THE FIRST CHURCH OF CHRIST, SCIENTIST  
PLAZA RESTORATION AND REPAIR PROJECT  
**BLC DESIGN REVIEW MEETING SIX - DRAFT**  
MAY 2, 2017

# REVIEW ITEMS FOR APPROVAL

MAY 23rd, 2017 AGENDA

MASSACHUSETTS AVE. GARDEN ENTRANCE  
**PROPOSED PLAN**

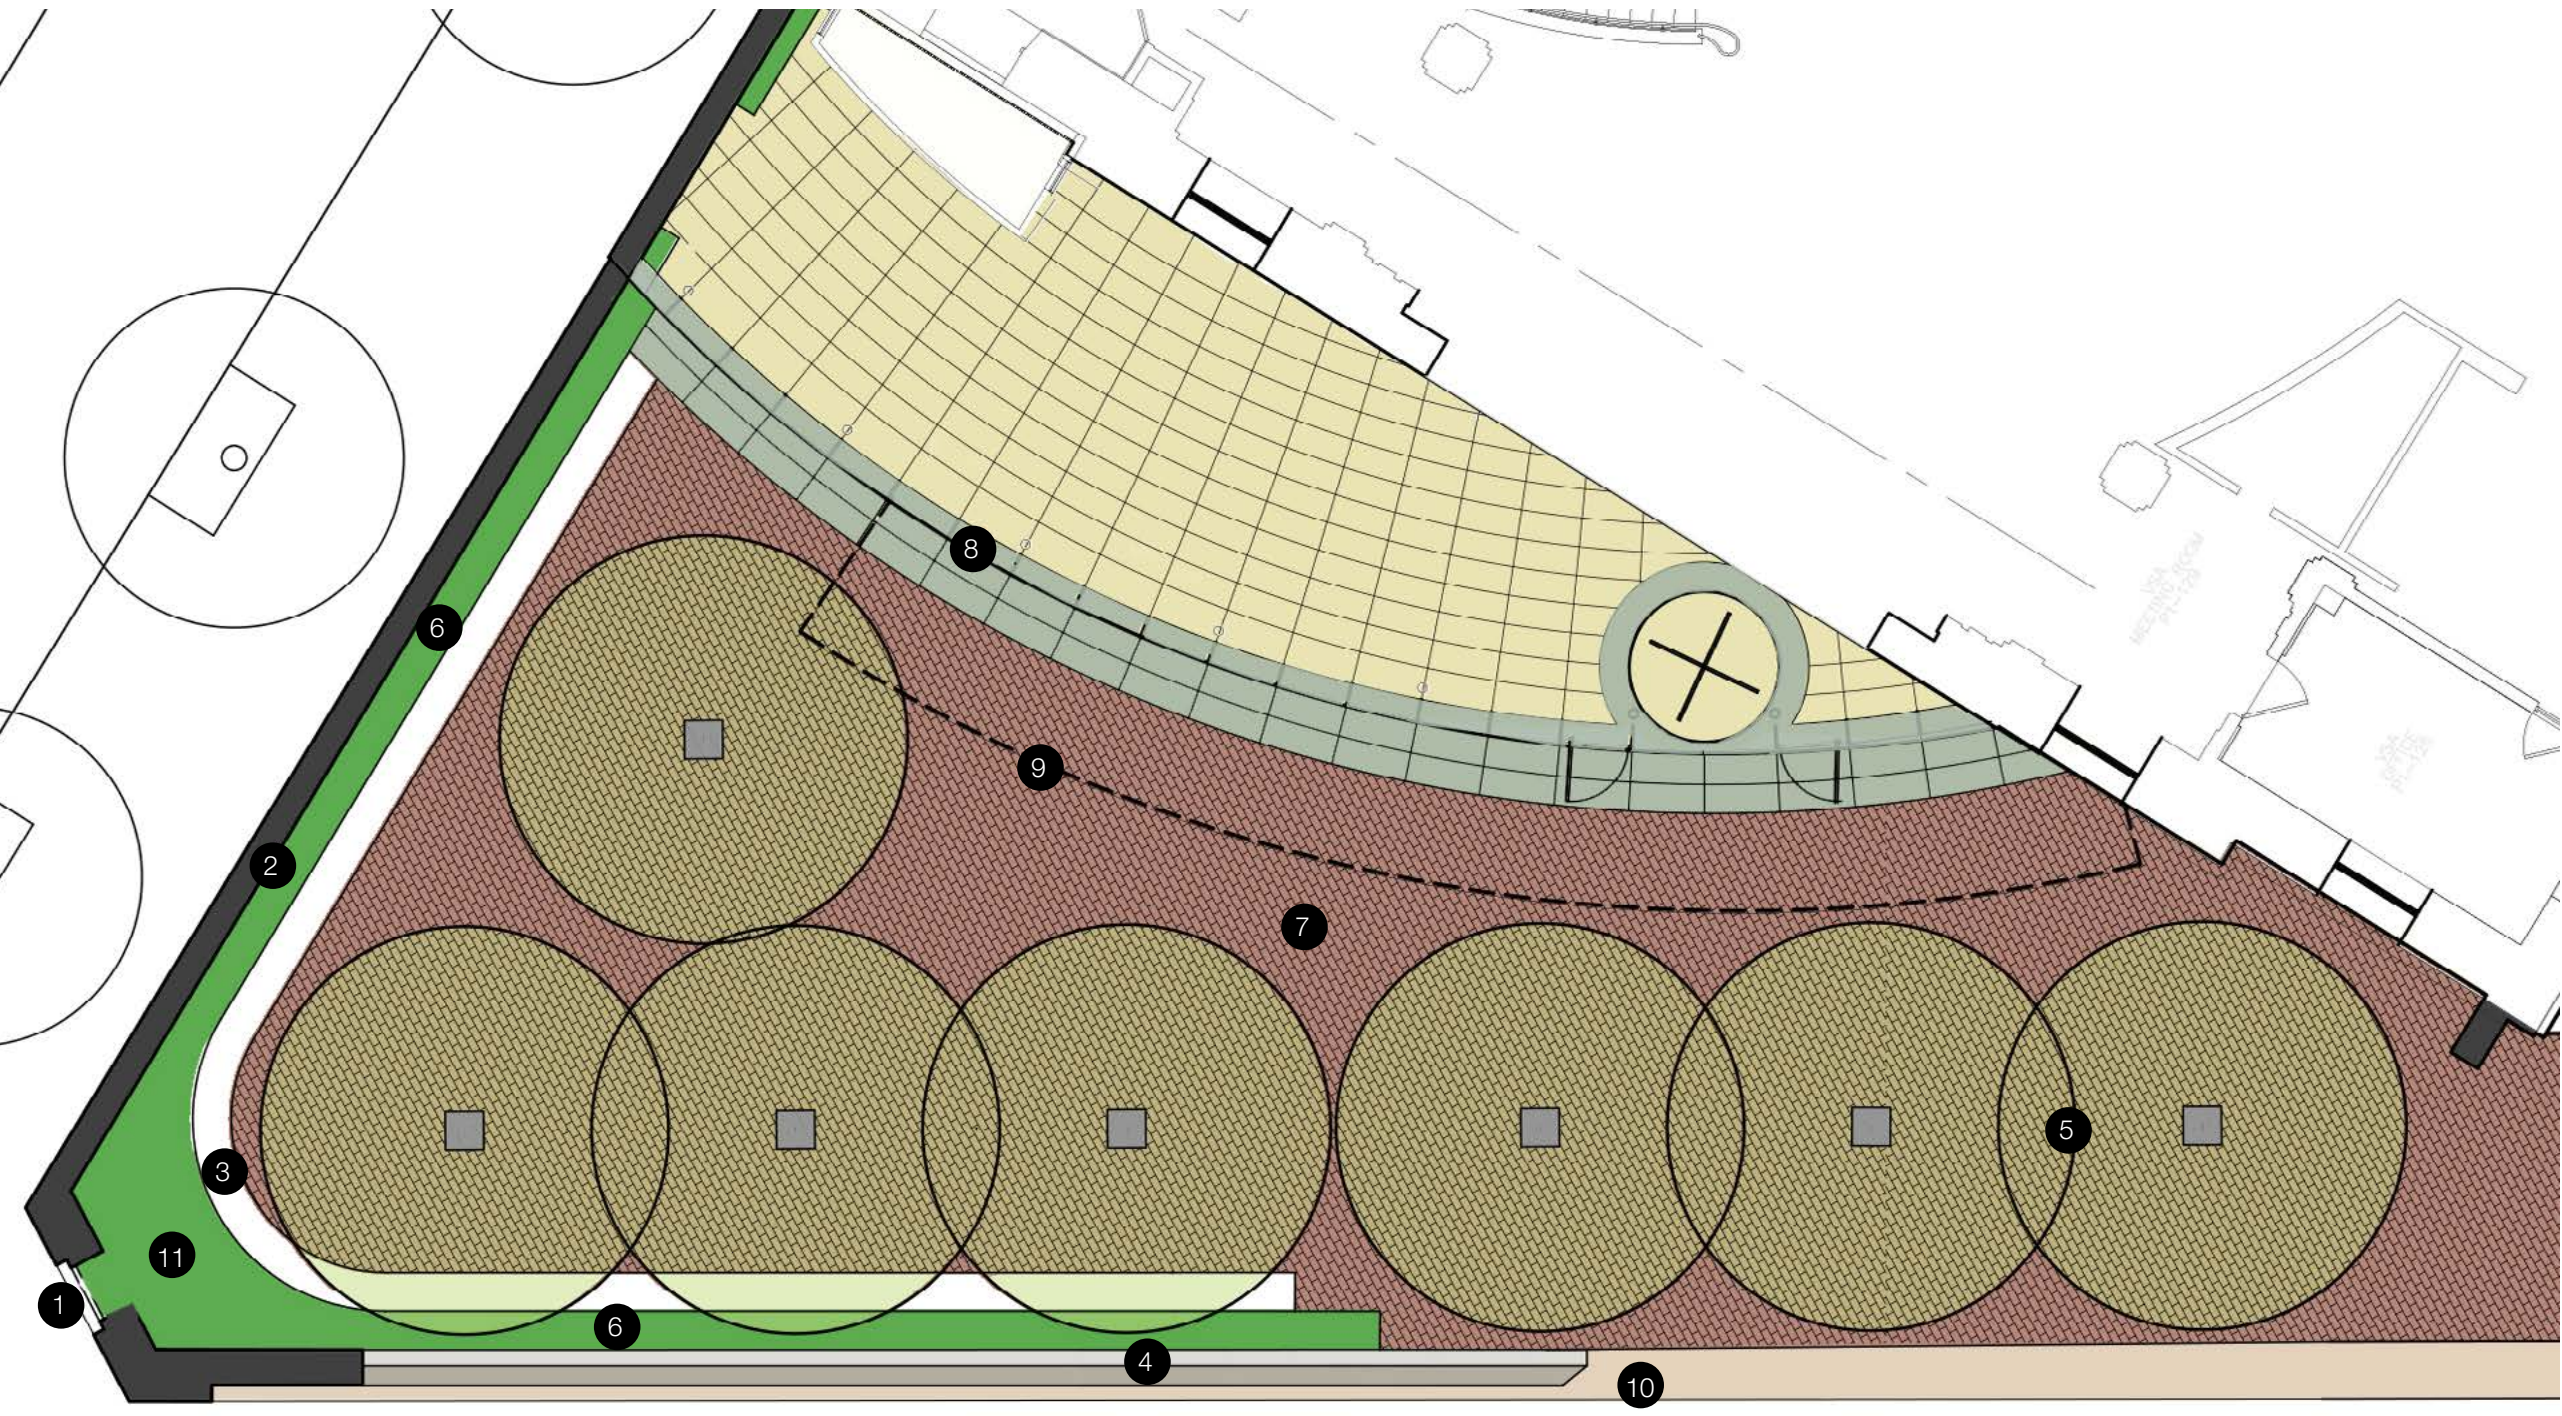
**Review the proposed Massachusetts Avenue Garden concept and address the following BLC comments from the April 12th Site Visit:**

- **Massachusetts Avenue Garden Concept**

- i. Study the floor treatment at the atrium glass wall to strengthen the indoor/outdoor visual connection.
- ii. Consider the viability of using moveable planter pots under the shade of the proposed tree canopy.

- **New Perimeter Wall Design**

- i. Study an intentional reveal to separate the old and new elements of the wall.
- ii. Study the approach from the Clearway Street corner to enhance the existing wall's welcoming function from this direction.
- iii. Consider the use of the stainless steel "slice" to replace the existing granite veneer end detail (from the 2001 substantial alteration) to be more consistent with the new plaza materials palette.
- iv. Study ending the new glass wall "more traditionally" rather than with the proposed signage element.
